**Comité d'experts du transport des marchandises dangereuses
et du Système général harmonisé de classification
et d'étiquetage des produits chimiques****Sous-Comité d'experts du transport des marchandises dangereuses****Trente-huitième session**

**Propositions diverses d'amendements au Règlement type
pour le transport des marchandises dangereuses****Observations concernant le document
ST/SG/AC.10/C.3/2010/39 – Utilisation éventuelle de
conteneurs pour vrac souples (CVS) pour le transport
de marchandises dangereuses****Communication du Président du groupe de travail par correspondance¹****Introduction**

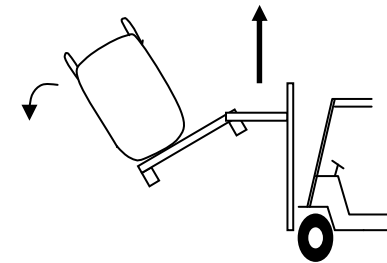
Testing Provisions	Belgium, Sweden, United Kingdom, Germany	<p><u>General Concerns:</u></p> <p>The UK is concerned about the overall stability of the proposed FBCs and does not believe that test procedures based on flexible IBCs properly addresses the dynamic issues encountered during transport for flexible containment systems of this size. In addition the UK does not believe FBCs are suitable for stacking particularly in land transport. The UK does not believe enough evidence has been submitted to demonstrate the FBCs are capable of successfully passing the test procedures when those procedures are rigorously applied.</p> <p><u>Drop test:</u> Belgium is concerned conducting the drop test on bare earth is not equivalent to conducting the drop test on a “rigid, non-resilient, smooth, flat and horizontal surface” (see for example 6.8.5.3.5.3).</p> <p><u>Top lift test:</u> Belgium is concerned the top lift test was not mentioned in UN/SCETDG/35/INF.27/Add.1.</p> <p>Sweden questions whether it is necessary to include a provision for alternative top lift test methods to be used subject to the approval of the competent authority.</p> <p><u>Righting test:</u> Belgium is concerned that the righting test should be conducted in conformance with ISO 16467:2003.</p> <p><u>Topple test:</u> Belgium is concerned the topple test conducted was not in conformance with written theory. See the following illustrations:</p>
